# HAM CR 96 3.92-SIDEWALK

THE PROJECT INVOLVES THE CONSTRUCTION OF NEW SIDEWALKS ON BOTH SIDES OF SPRINGDALE ROAD FROM POOLE ROAD TO YELLOWWOOD DRIVE.

STAGE 3 SUBMITTAL - JULY 23, 2023

**TRAFFIC CONTROL PLAN - SPRINGDALE ROAD**  
 STA. 130+00 to STA. 135+00

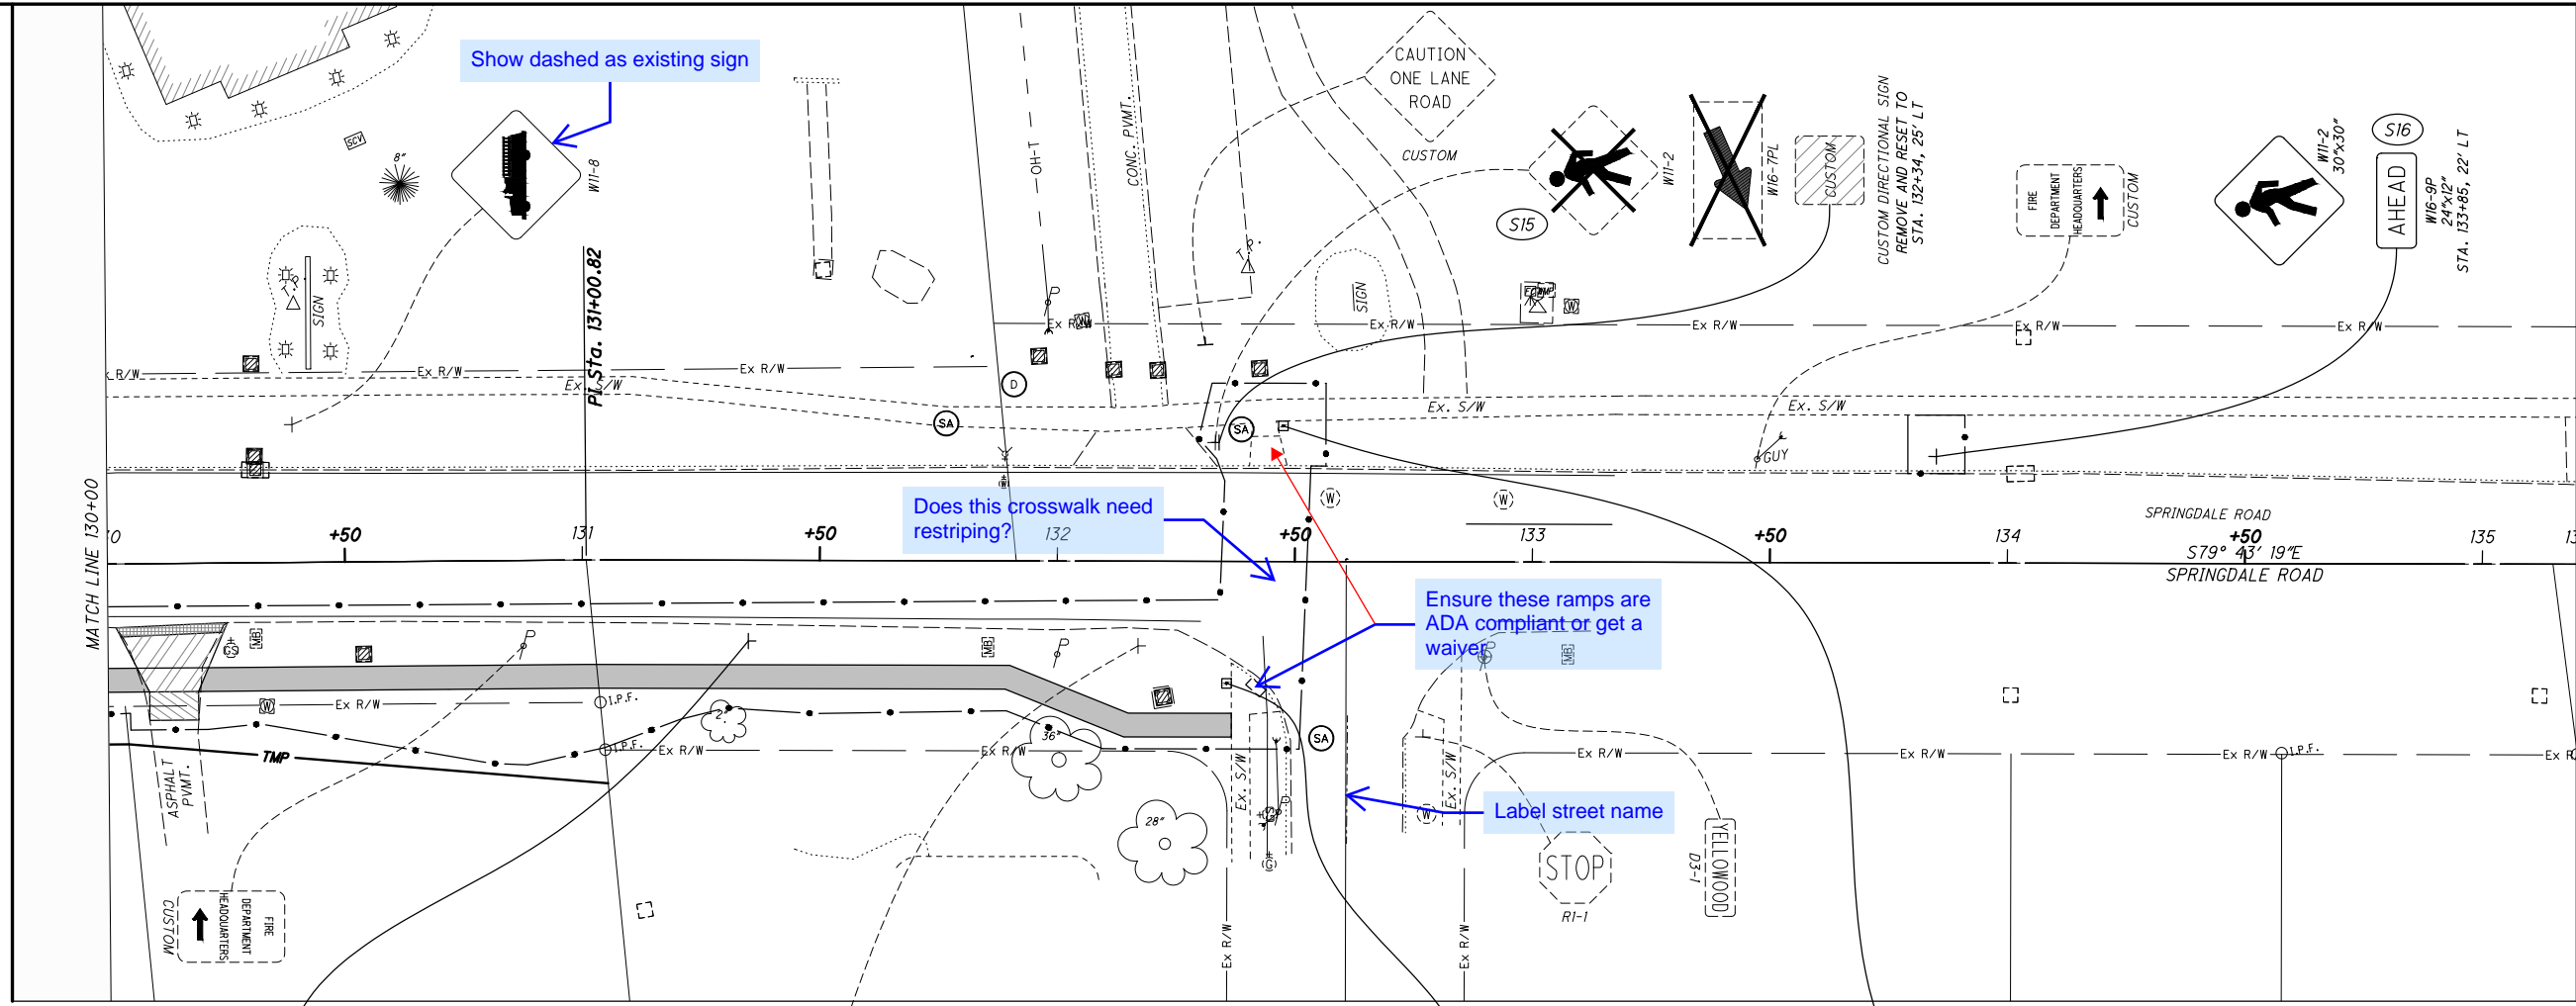
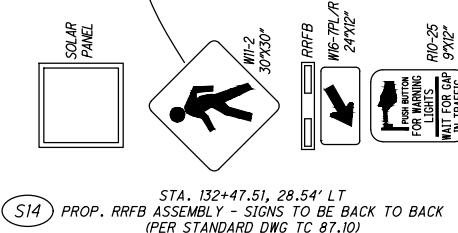
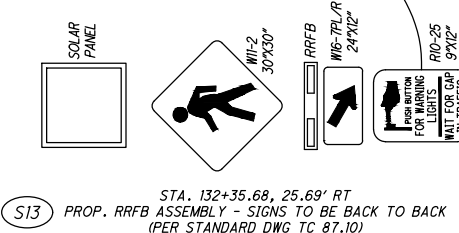
Show dashed as existing sign

Does this crosswalk need restriping?

Ensure these ramps are ADA compliant or get a waiver

Label street name

GREATER CINCINNATI  
**WATER WORKS**  
 ENGINEERING DIVISION / DESIGN SECTION  
 3845 EASTERN AVENUE, CINCINNATI, OHIO 45226

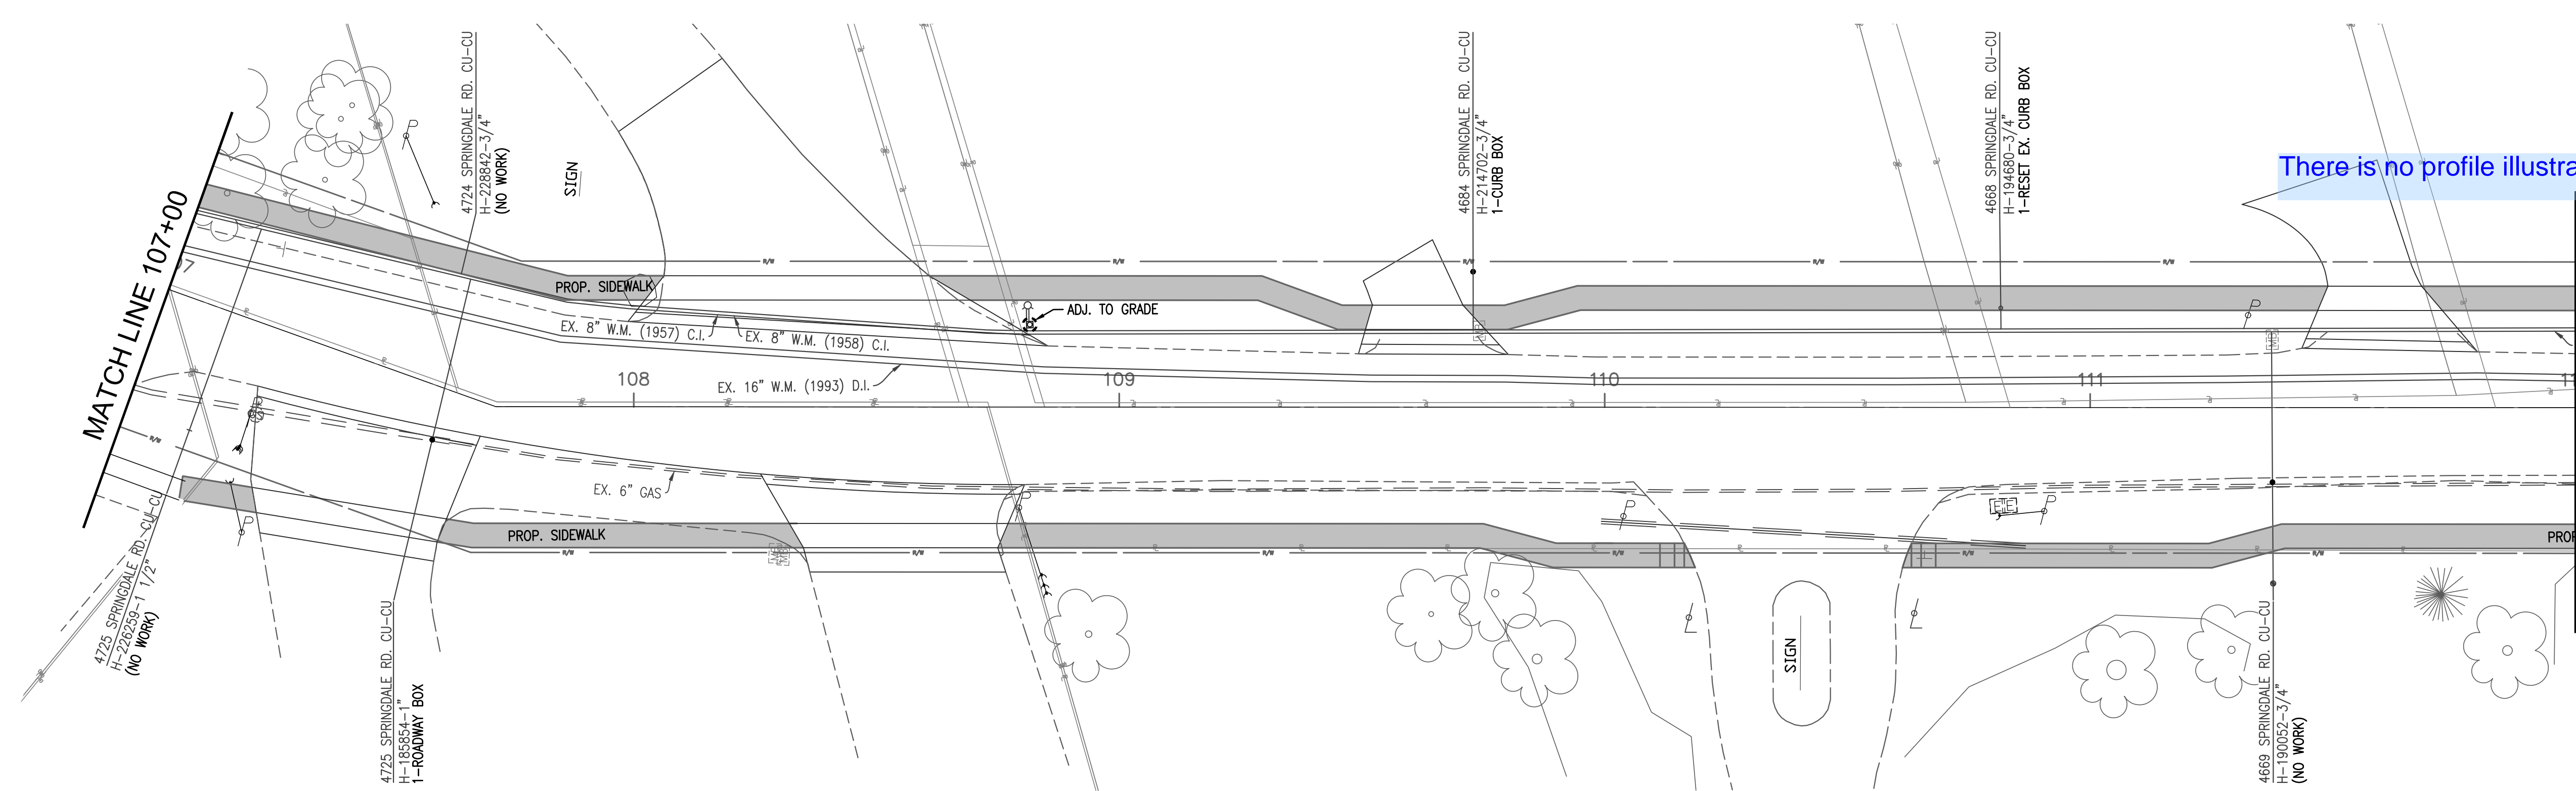
There is no profile illustrated.

# SPRINGDALE ROAD

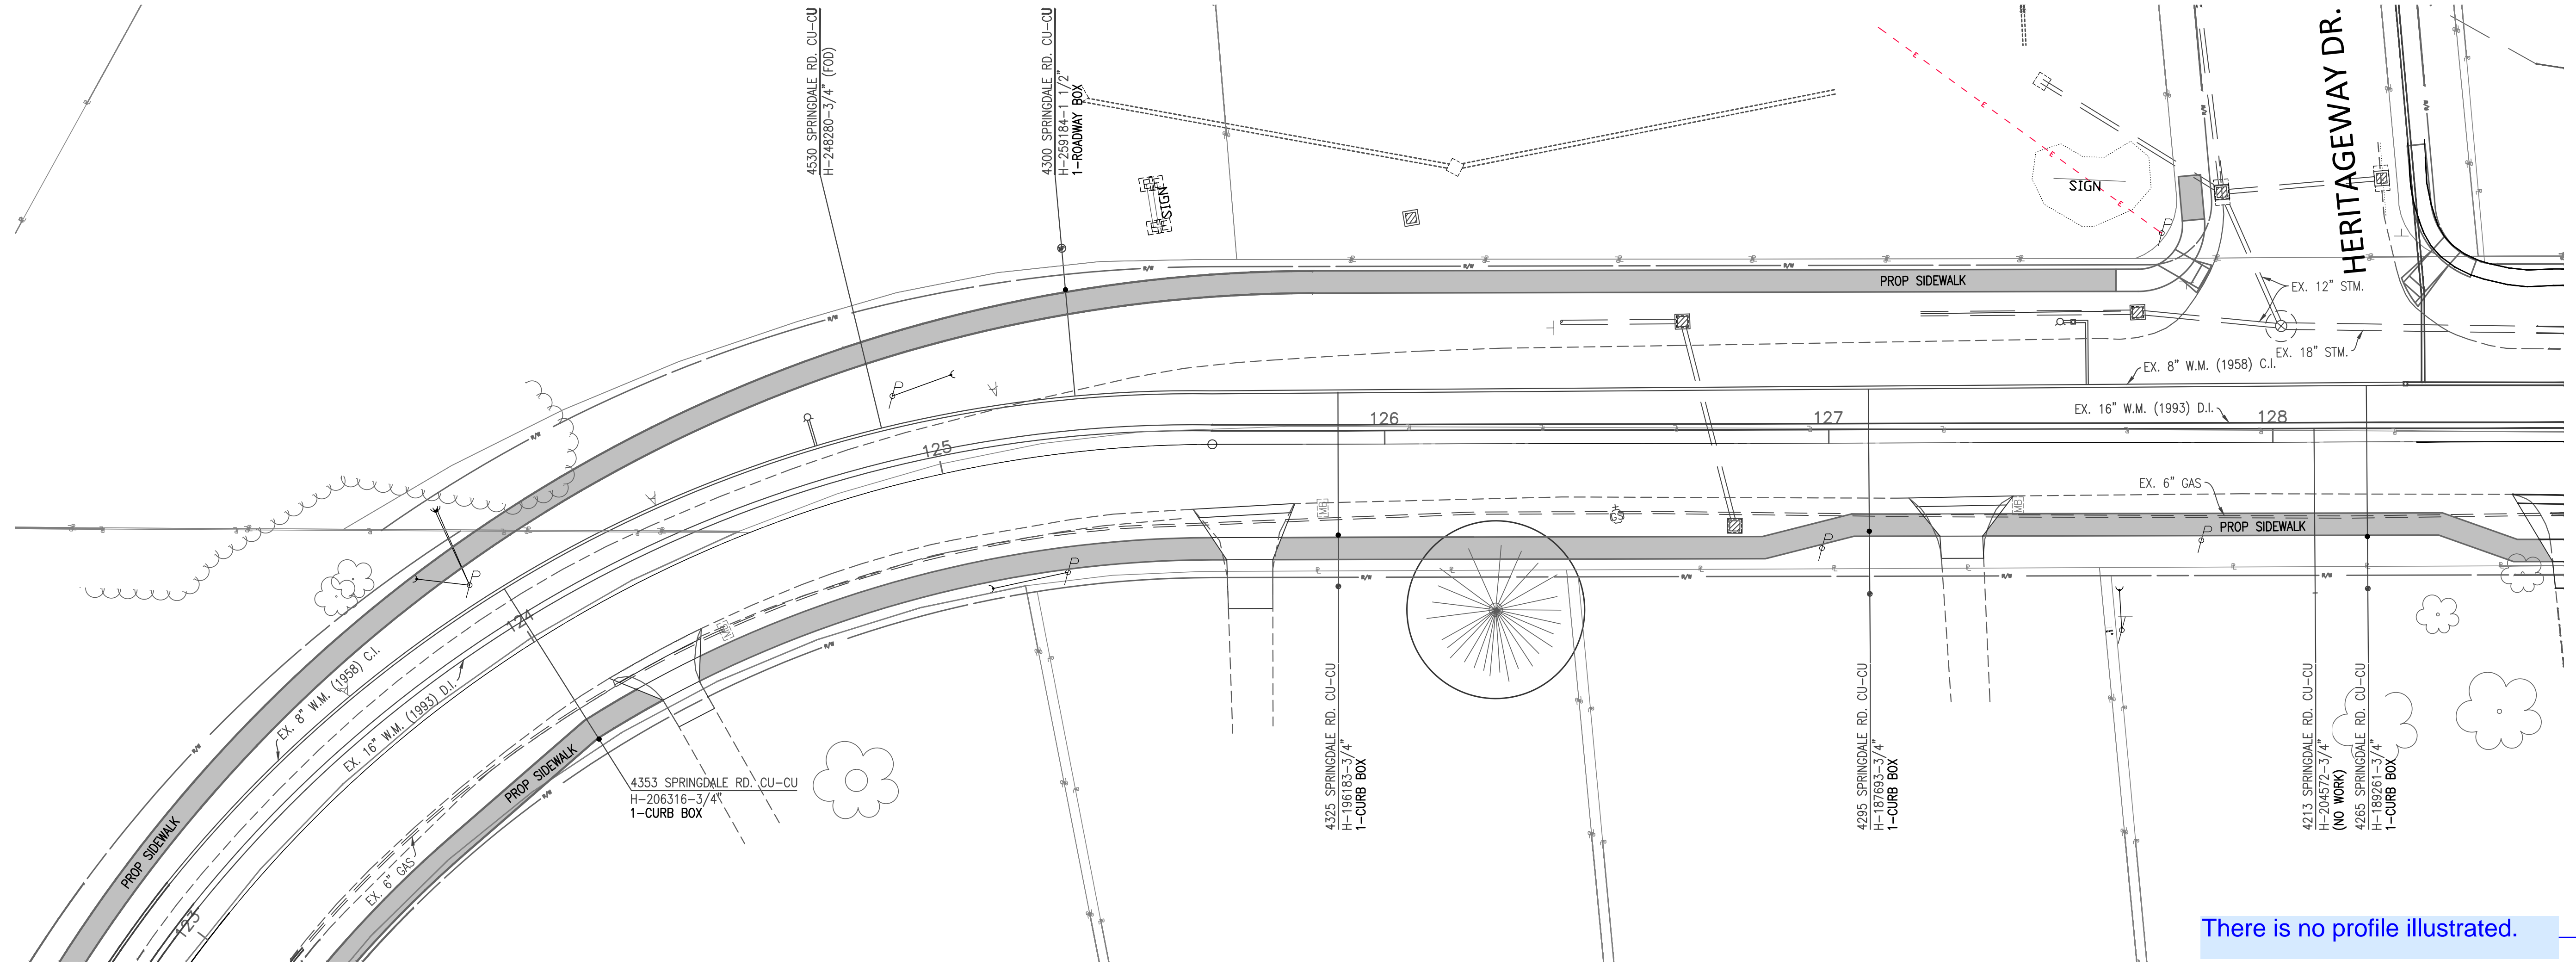
There is no profile illustrated.
